DEVELOPMENT REVIEW BOARD - **HYDROLOGY SECTION**

DRB Project Number: 2022-007518 Hearing Date: **08-31-2022**

Project: Tract B-1, Cibola Loop Subdivision Agenda Item No: **12**

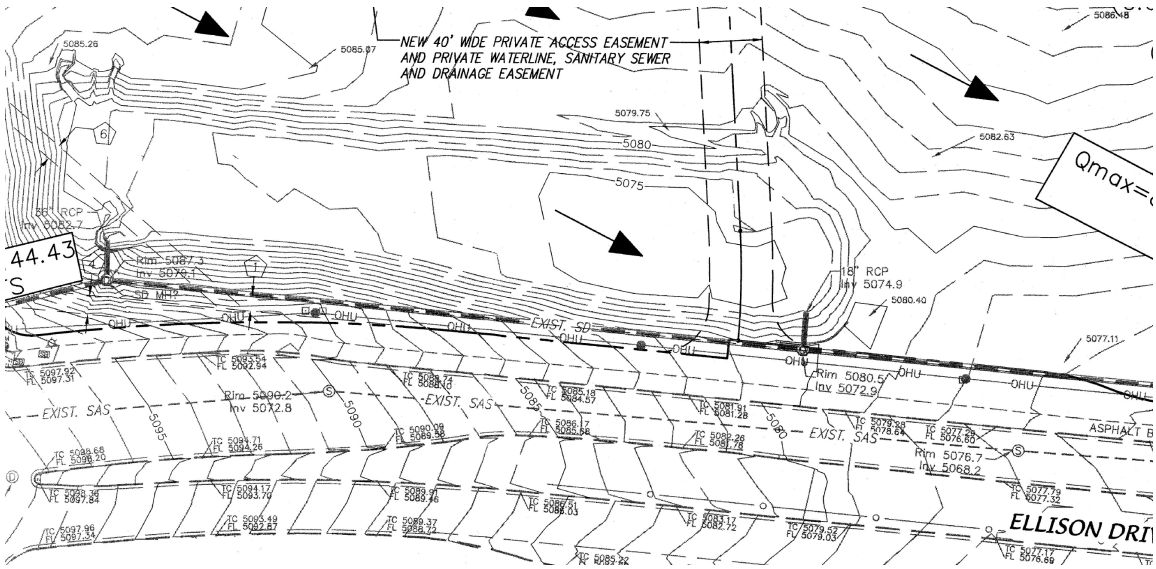
- The existing Cibola Loop Detention Pond and the Pond's outfall are currently on Tract B-1 and the 40' Private Access Easement.

- Hydrology needs to approve a Drainage Report and revised Grading Plan for the Cibola Loop Detention Pond prior to approving any platting action.
- Hydrology will need to approved Tract B-1 Grading & Drainage Plan is required prior to Building Permit if one of these conditions is met. (500 cy of grading, 1,000 sf of proposed building, or 10,000 sf of proposed paving).
